RE: 102 Alta Heights Court

ISSUES AND CONCERNS

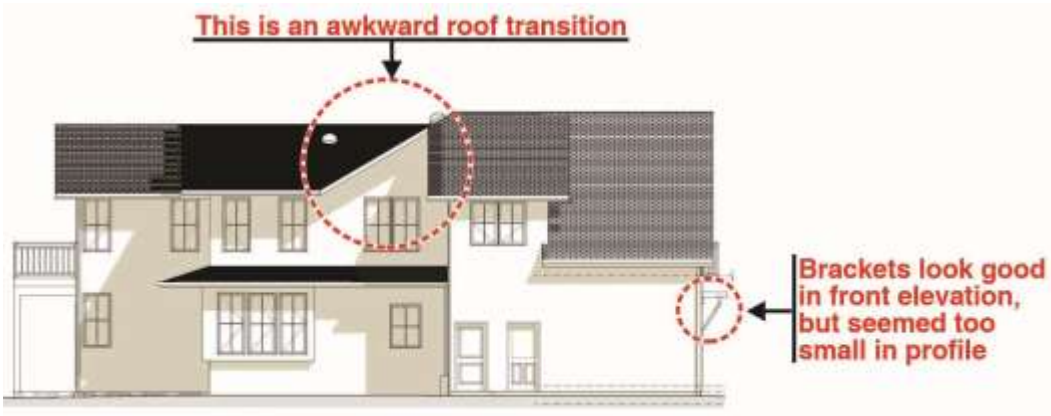
2. There is a rather awkward roof transition on the left side elevation which is complex and inconsistent with the traditional simplicity of the Tudor Style.

Response: See A3.4, the roof was redesigned to be more uniform and the dormer roof at the ADU was lowered to be a smaller feature which then allowed the main, upper ADU/Garage roof to turn the corner in a very small, hip roof at the back which is cleaner.
